Model: Hadar-PJ1XGA		Date: 30-Oct-15	No.: RY088001
Subject: I/O shift issue		Prepared by: T. Takahashi	
From: 1st Tech Service Sect., MFP/P Tech Service Dept.			
Classification:	<input checked="" type="checkbox"/> Troubleshooting <input type="checkbox"/> Mechanical <input type="checkbox"/> Paper path <input type="checkbox"/> Product Safety	<input type="checkbox"/> Part information <input type="checkbox"/> Electrical <input type="checkbox"/> Transmit/receive <input type="checkbox"/> Other ()	<input type="checkbox"/> Action required <input type="checkbox"/> Service manual revision <input type="checkbox"/> Retrofit information <input type="checkbox"/> Tier 2

Affected models: Hadar-PJ1XGA (Y088)

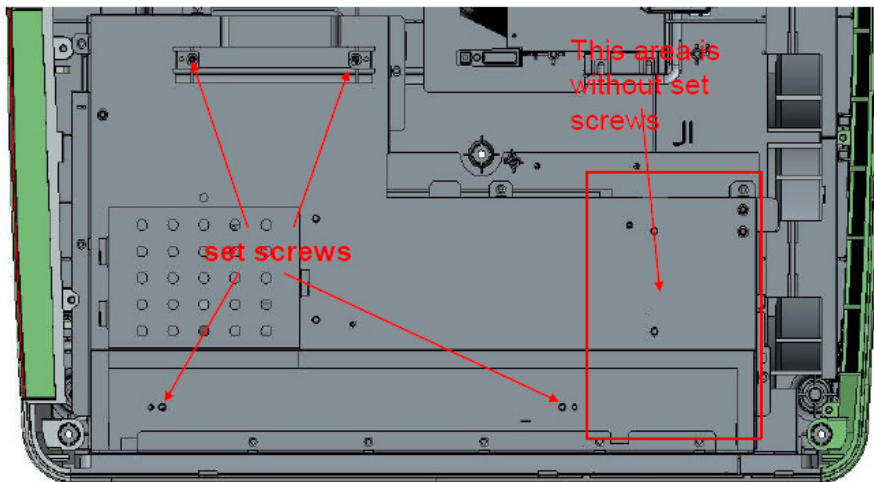
The I/O port on the MB Module cannot be accessed (connector cannot be connected).

The screws on the right side of the MB bottom shielding come loose. As a result, the MB module is raised with respect to the outer cover.

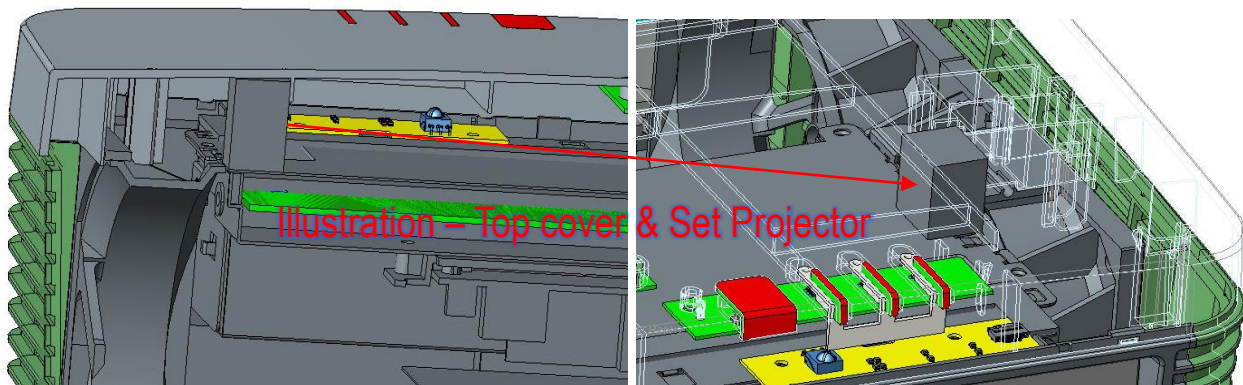
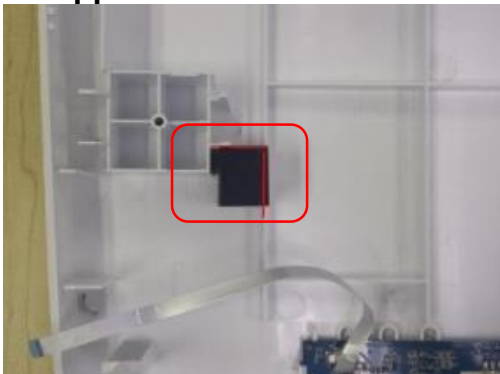
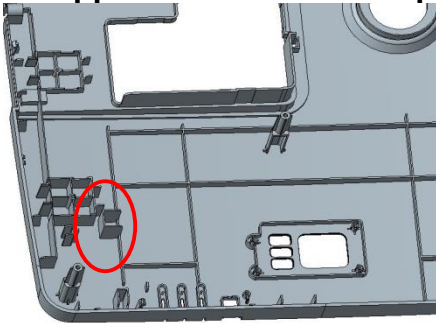
1. A rubber spacer was added to the top cover to hold the MB module in place.

Applied from: 9/22/15

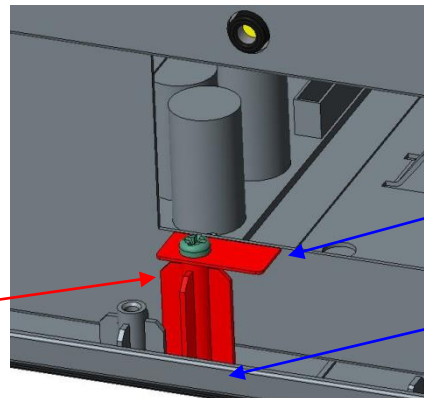
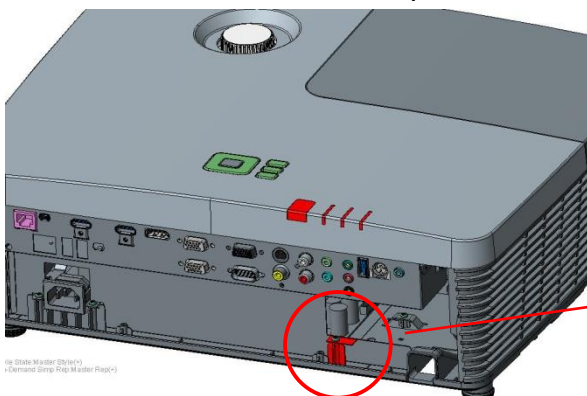
2. A rib was added to the top cover to hold the MB module in place.
Applied from: End of Sept. 2015

3. The parts highlighted in red were added to the bottom cover and LVPS shielding to hold the LVPS and MB module in place.
